HISTORIC LANDMARK COMMISSION
STAFF REPORT

Petition 470-08-01 Liberty Park Children's Garden
New Construction and Major Alterations to a Landmark Site
Between 500-700 East and 900-1300 South Streets
March 5, 2008

REQUEST

Figure 6 -- New boat dock and extension to Liberty Lake shoreline.

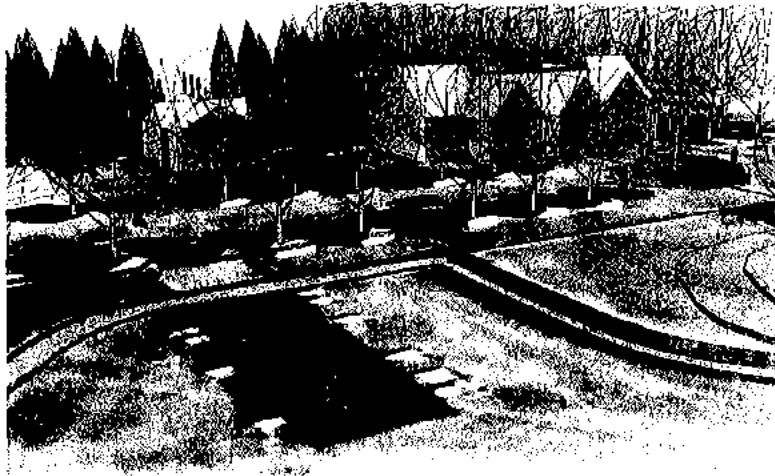
Boat Dock: It is not clear from the plans what the proposed width of the new boat dock will be. From the conceptual drawing, the dock seems large for such a small body of

1. Approval of the final details for the First Phase improvements shall be delegated to the Planning Staff based upon direction given during the hearing from the Historic Landmark Commission.
2. Based upon direction given during the hearing from the Historic Landmark Commission, final details for the Second and Third Phase of the Conceptual Plan shall return to the Historic Landmark Commission for review. The location of the gazebo will affect the visual appearance of the rolling landscape of the park and is not permitted. A new gazebo shall be as unobtrusive as possible and complement the visual continuity and cohesiveness of the historic site. The relationship of the width and length of the boat dock shall be in scale with Liberty Lake and surrounding park features.

Figure 26 - Typical cross-section of the proposed dry stream bed.

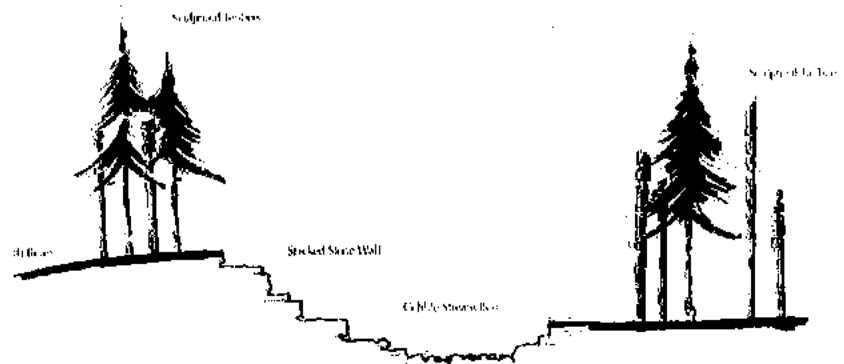
Dry Stream Bed: The plans do not show sufficient detail for Staff to fully evaluate the proposed feature. Final details of this feature should be reviewed by the Historic Landmark Commission.
